Product Change Notification(PCN)

A-PCMCIA-68-F-x-x-003

Compact Flash Receptacle Clip Memory Card conn.

Change Notification: PCN 20190618 A-PCMCIA-68-F-x-x-003

| A-PCMCIA-68-F-x-x-003 Old version | A-PCMCIA-68-F-x-x-003 New version |

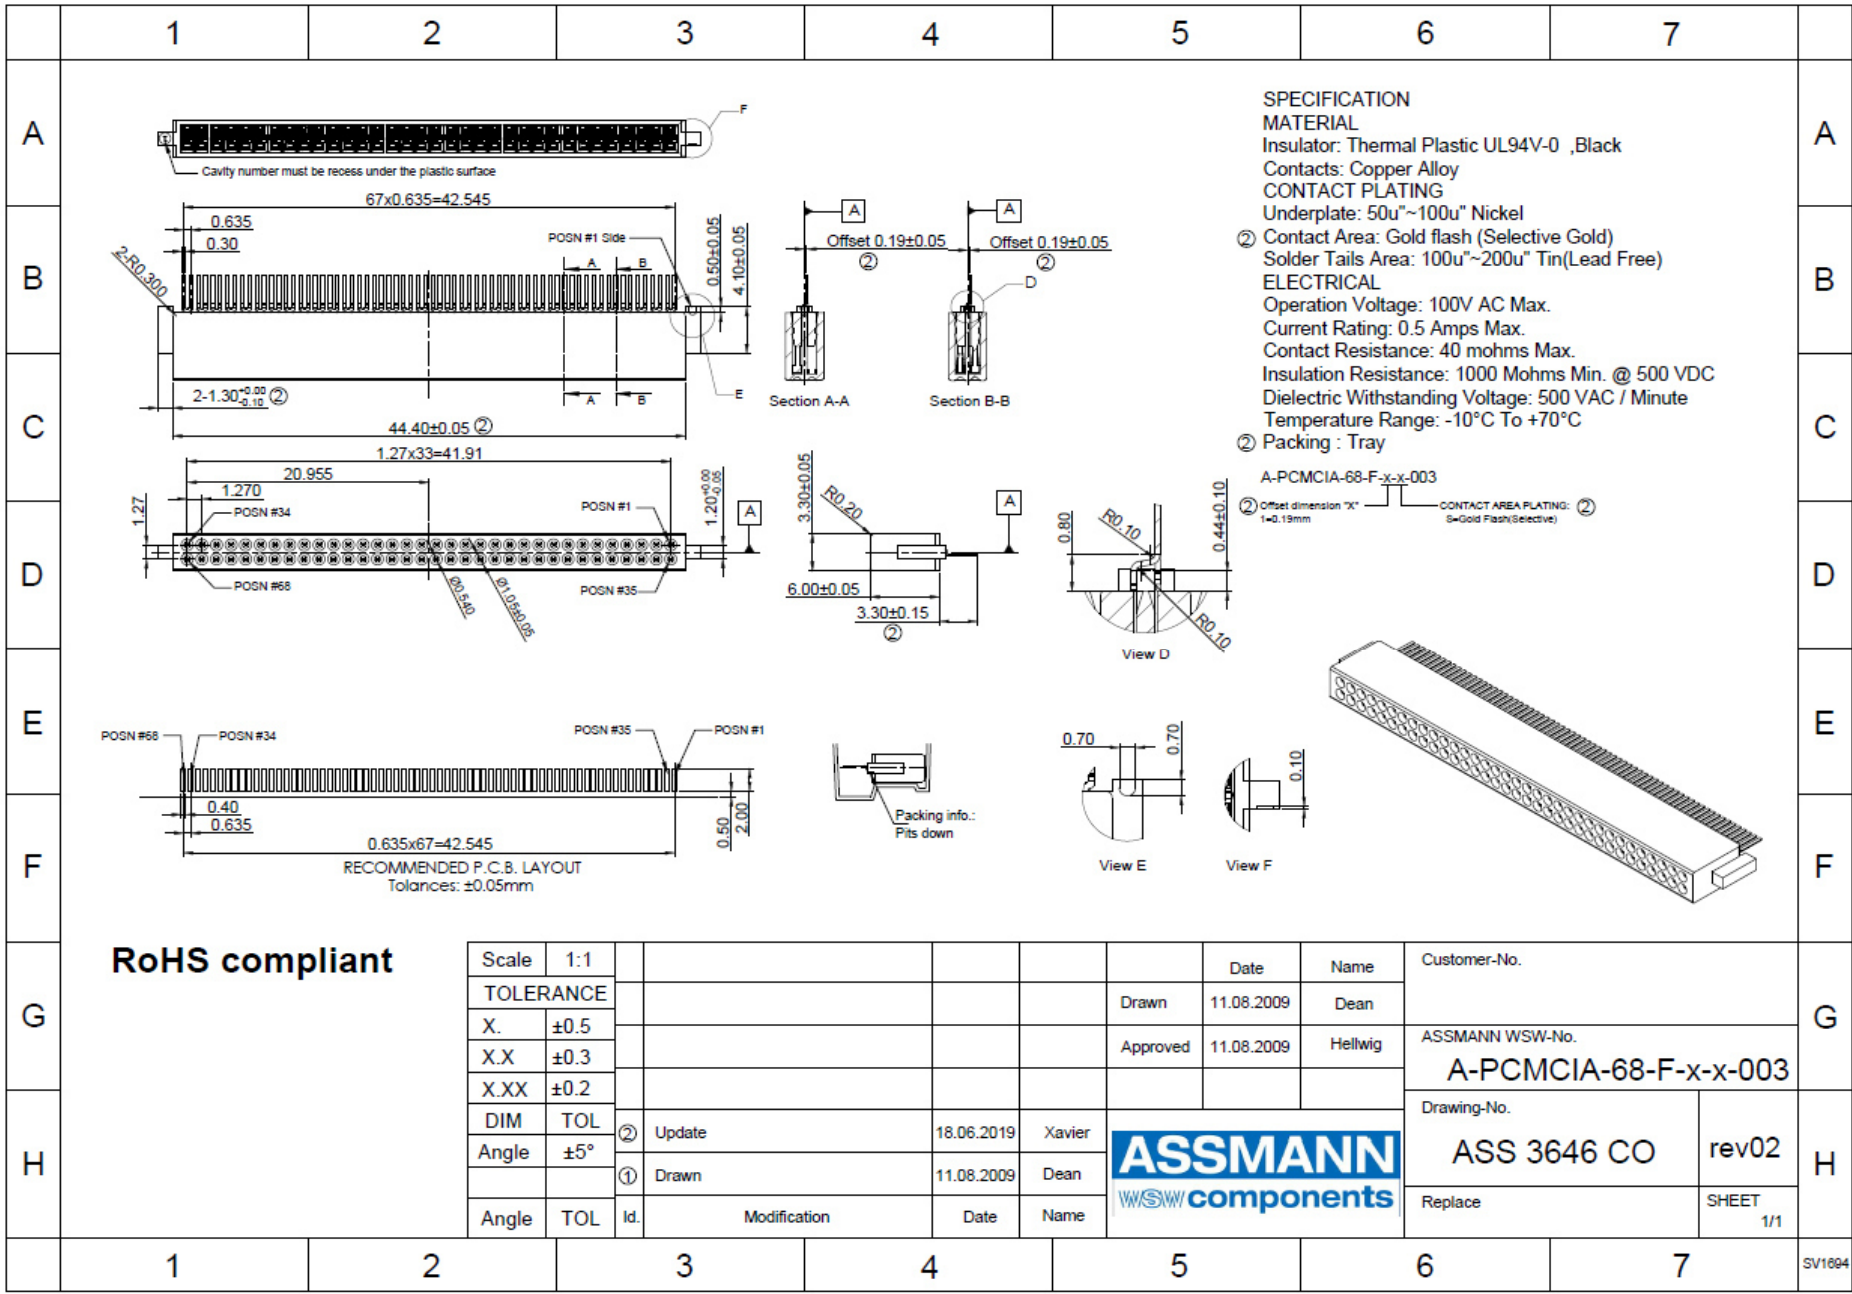
| A-PCMCIA-68-F-x-x-003 Old version | A-PCMCIA-68-F-x-x-003 New version |
|--|---|
| <p>1. Plating option</p> <p>Contact Area: 1u"~30u" Selective Gold</p>  <p>2. Packing type</p> <p>Packing : Tube</p> <p>3. Offset dimension option</p>   <p>4. Dimensions</p> <p>4-1</p>  <p>4-2</p>  <p>4-3</p>  | <p>1. Plating option</p> <p>Contact Area: Gold flash (Selective Gold)</p>  <p>2. Packing type</p> <p>Packing : Tray</p> <p>3. Offset dimension option</p>   <p>4. Dimensions</p> <p>4-1</p>  <p>4-2</p>  <p>4-3</p>  |

| A-PCMCIA-68-F-x-x-003 Old version | A-PCMCIA-68-F-x-x-003 New version |
|--|---|
| <p>For detail, please take attached new drawing: ASS_3646_Corev02 for reference</p> | |
